STAFF REPORT

Site Plan Review and Variances (Type III Review)

SUBJECT: **#187-ZON16-070 Site Plan Review and Variances for a new specialty retail grocery use containing approximately 13, 560 square feet.**

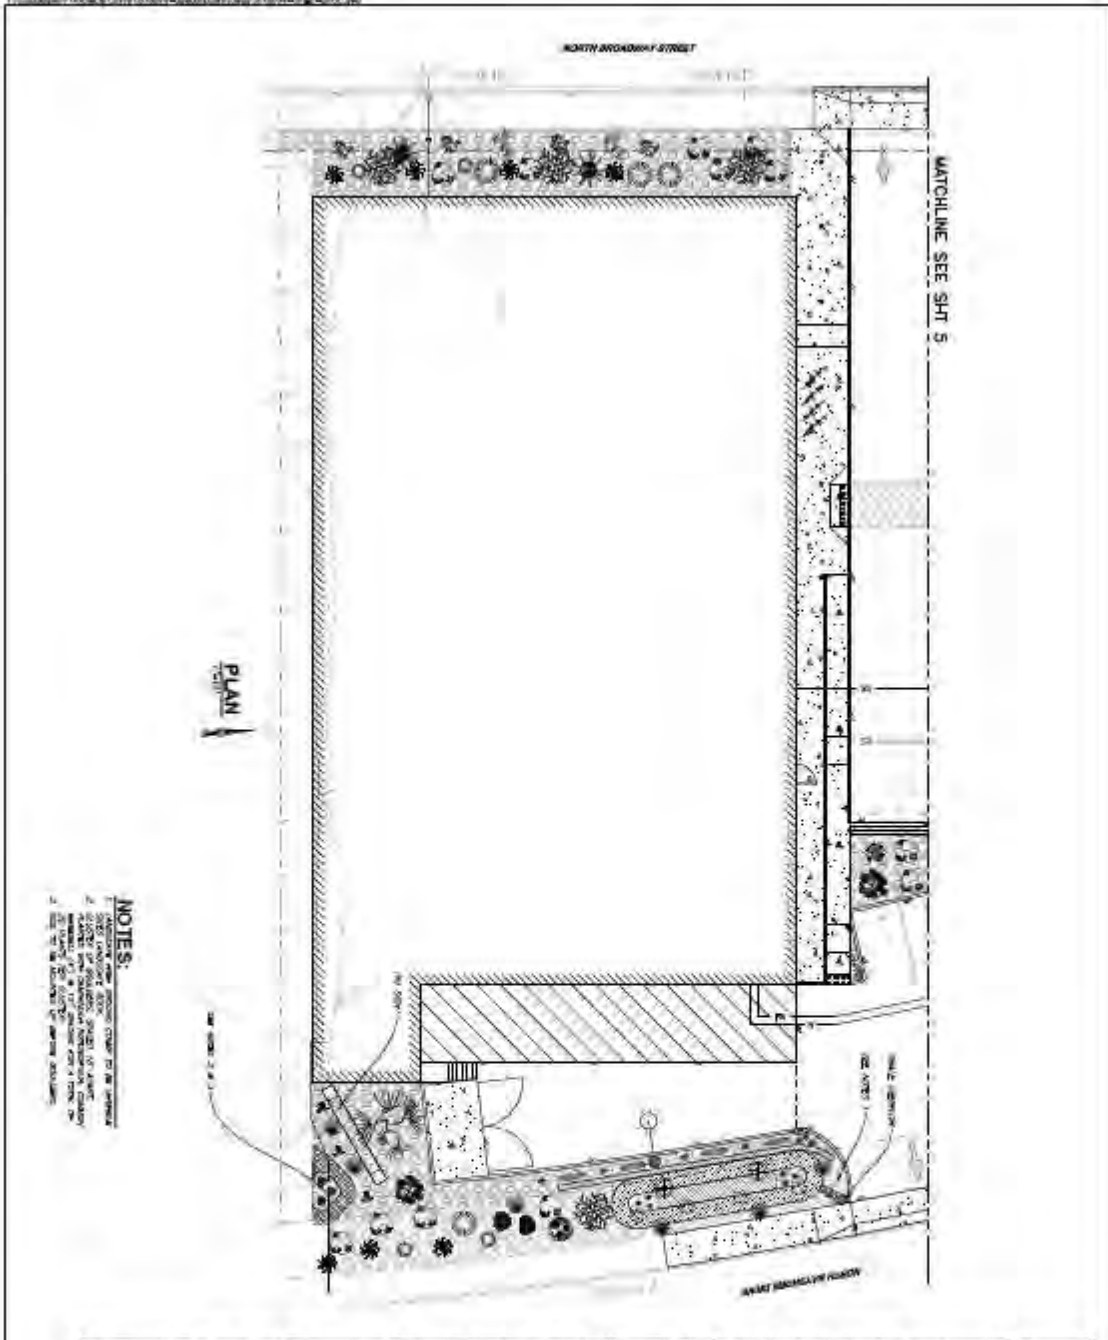
"The public sanitary sewer line is approximately 50 feet north of the property. Specialty Grocery is proposing to connect their private sanitary sewer lateral to the public manhole located on Alder Avenue. There is a potential risk involved with connecting into a manhole. An inside drop is required and applicant takes full responsibility for any damage to the public manhole associated with the connection. The contractor must core drill into the manhole and use a flexible rubber boot KOR-N-SEAL or equal as approved.

The storm water will be captured on site and flows will travel to a proposed swale on the northeast side of the property. The flow then travels to a public storm catch basin on North Broadway Drive. Specialty Grocery is proposing to connect their private storm sewer lateral to the public catch basin located on Bayshore Drive. There is a potential risk involved with connecting into a catch basin. The applicant takes full responsibility for any damage to the public catch basin associated with the connection. The contractor must core drill into the catch basin and use a flexible rubber boot KOR-N-SEAL or equal as approved.

The proposed plan has private catch basins and the roof drain connecting into a swale at the northeast side of the property. The flow then travels to a public storm catch basin on North Broadway Drive. There is also a swale over flow on the east side of the property that directs flow to the street on North Broadway Drive. Stormwater Drainage Plan prepared December, 2016 by SHN Consulting Engineers and Geologist, Inc concluded that the "runoff from the proposed improvements will reduce runoff to the existing storm system by roughly 1.44 cfs during the 25 year design storm event. All stormwater being detained onsite will either infiltrate into the ground or be stored to attenuate the storm event".

1. The applicant shall secure all building and other applicable permits, as required, from the City of Coos Bay or the State of Oregon.
2. The project development shall occur in substantial conformance with the submitted site & grading plan and landscaping plans dated 12/2016.

3. An inside drop for the sanitary sewer is required and the applicant takes full responsibility for any damage to the public manhole associated with the connection. The contractor must core drill into the manhole and use a flexible rubber boot KOR-N-SEAL or an equivalent, as approved by the Engineering Division.

4. The applicant takes full responsibility for any damage to the public catch basin associated with connection to the City's storm sewer system. The contractor must core drill into the catch basin and use a flexible rubber boot KOR-N-SEAL or an equivalent, as approved by the Engineering Division.
